<b>Subject:</b>  <b>CHECK ENGINE LIGHT ON WITH DTC P0300-P0304</b>	<b>Bulletin No:</b> 01-014/16
	<b>Last Issued:</b> 07/29/2016

This bulletin supersedes the previously issued bulletin(s) listed below. The changes are noted below in Red beside the change bars.

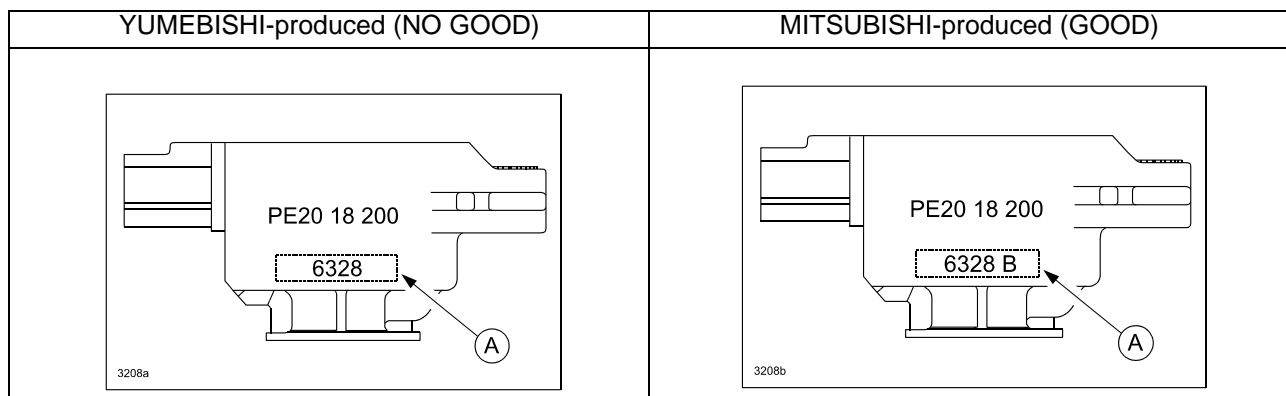
To distinguish between YUMEBISHI and MITSUBISHI ignition coils, look at their lot numbers (A). YUMEBISHI have 4 digit lot numbers and MITSUBISHI have 5 digit lot numbers as shown.

6	Year (4=2014, 5=2015, 6=2016)
3	Month (1=Jan, 2=Feb, 3=Mar...X=Oct, Y=Nov)
2	Day
8	
B	MITSUBISHI-produced only (A=Daytime, B=Nighttime)

**NOTE:** There is no part number change. Differentiate the new modified ignition coil (YUMEBISHI-produced) from the old one by the lot number on the ignition coil. Ignition coils with the lot number of 6328 (March 28, 2016 production) or higher are modified.
